SERVICE BULLETIN

SB-2026-047 Lowering valve check

SB-2026-047
Issued Sep 30, 2026

Affected component

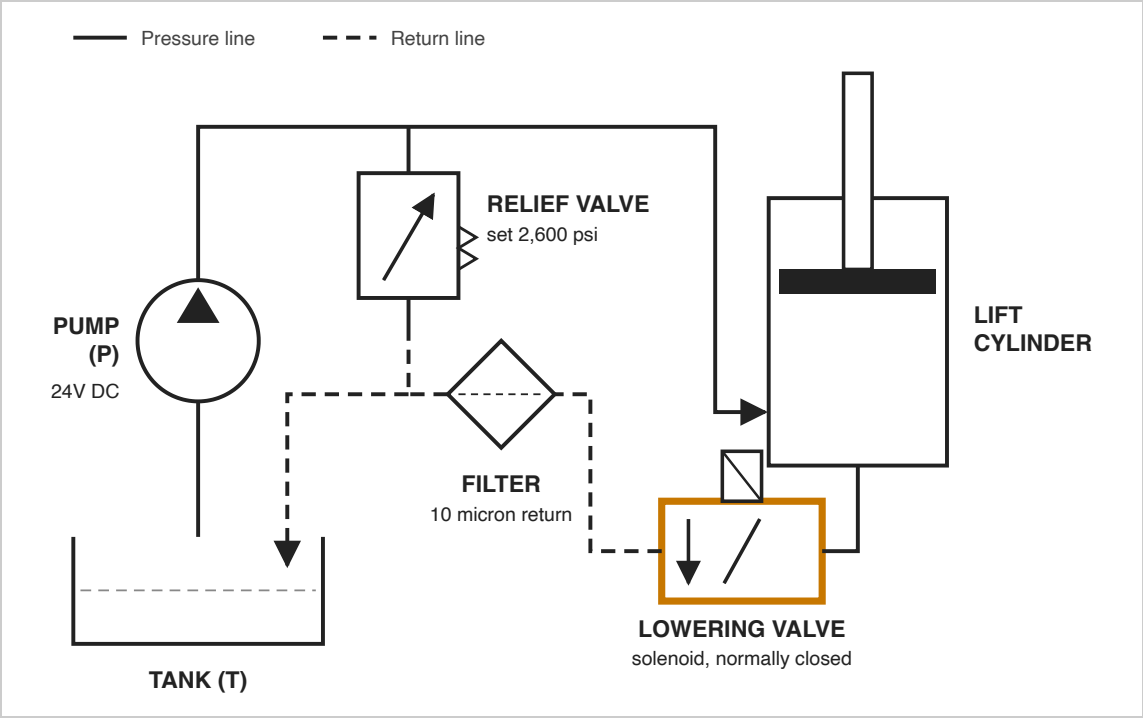
Some lowering valves may not seat fully after long idle periods. The platform can then drift down slowly with a load on it. This check confirms the valve seats and holds pressure.

1. Park on firm, level ground. Load the platform with 300 lb of test weight.
2. Raise the platform to 6 ft and turn the key switch off.
3. Mark the rod position. Wait 10 minutes.
4. If the platform drifts less than 0.5 in, the valve passes. Record the result below.
5. If it drifts more, replace the lowering valve with JLG-4120-402 and repeat the check.
6. Return the machine to service and close the work order.
